December 28, 2012

RE: SUM-SEIBERLING PHS 2
3GC05686*AG
STORMWATER
SUMMIT COUNTY

On December 19, 2012, this writer inspected the above referenced construction site for the purpose of determining compliance with General Construction National Pollutant Discharge Elimination System (NPDES) Permit No. 3GC05686*AG. Below is a summary of my observations:

Concrete Pier on east side of site, isolating Haley's Ditch.

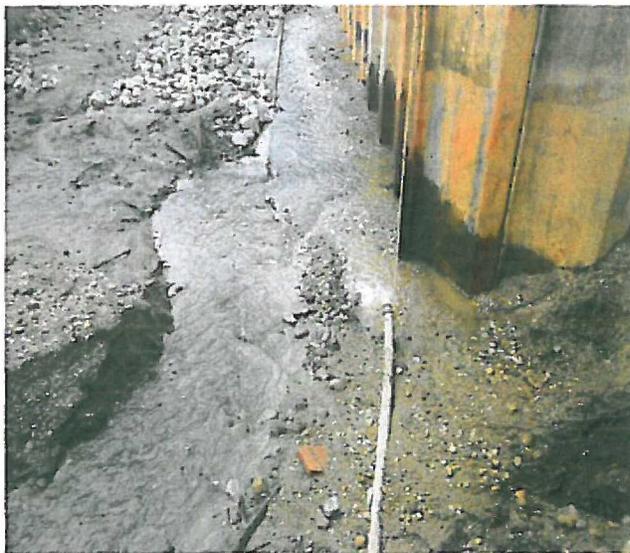
- 1) A review of the most current Storm Water Pollution Prevention Plan (SWPPP) in the construction trailer was done. The most current SWPPP did not contain any updates that reflect the changes that have been made to the handling of storm water on the east side of the site. As noted in previous site inspection letters, Detention Area 1 was not present. On this day, any storm water generated would collect behind the concrete pier as depicted in the following picture:

Reportedly during small storm events, the collected water infiltrates west to east under the concrete pier due the sandy soils and the rock base of the pier. Accumulated water it is then pumped directly to Haley's Ditch on the downstream side of the work area. During extended heavy rainfall this system can be overwhelmed backing up on the west side of the pier where it is then pumped directly to Haley's Ditch. This water is not receiving any treatment as it is not being pumped to the berm and subsequently to Detention Area 2, Detention Area 3 and finally to the storm water detention basin on the west side of the site. This BMP system is required by your currently approved SWPPP. As stated in this writers previous letters, **failure to implement sediment controls in compliance with the SWPPP is violation of Part III.G.2.d of NPDES Permit 3GC05686*AG and Ohio Revised Code (ORC) 6111.04 and 6111.07.**

Alterations or modifications to the BMP system must be formally documented by amending the SWPPP drawings and any associated verbiage. Please be advised that any changes to the SWPPP erosion and sediment controls for the site must be designed in accordance with Part III.G.2.d of the General Permit. The current practice does not appear to meet the aforementioned specifications. Should the specifications be met with the current practice it is still not acceptable as the discharge has been observed by this writer to discharge turbid waters that discolor the downstream waters of the state. **This is a violation of the general water quality criteria specified in Ohio Administrative Code 3745-1-04.**

North end of redirected Haley's Ditch

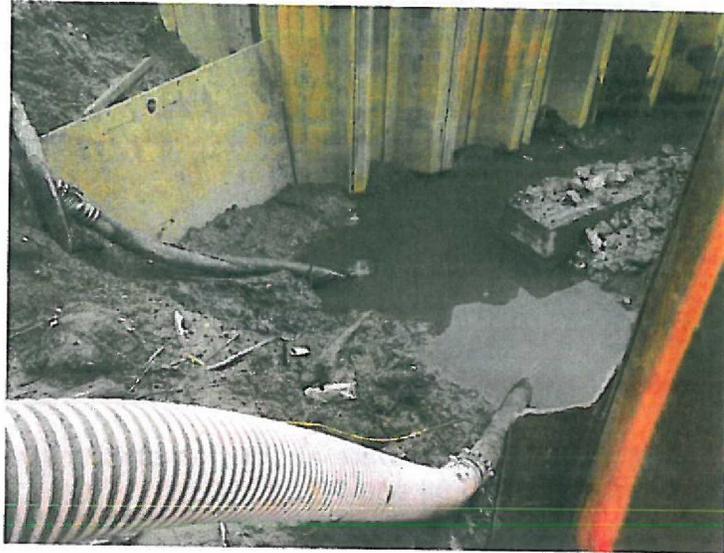
- 3) The excavation area east of the redirected Haley's Ditch was also being pumped at the time of the inspection. The water is allowed to travel thru the work area where it is being pumped from the north end and into Haley's Ditch downstream of the site. At the time of the inspection, the pump inlets were located at the bottom of the excavation. No well point/filter was being used on the north end.

Area east of the redirected Haley's Ditch.
Note extremely turbid water.

The above listed and depicted practices are a violation of Part III.G.2.g.iv of the NPDES Permit 3GC05686*AG and ORC 6111.04 and 6111.07.
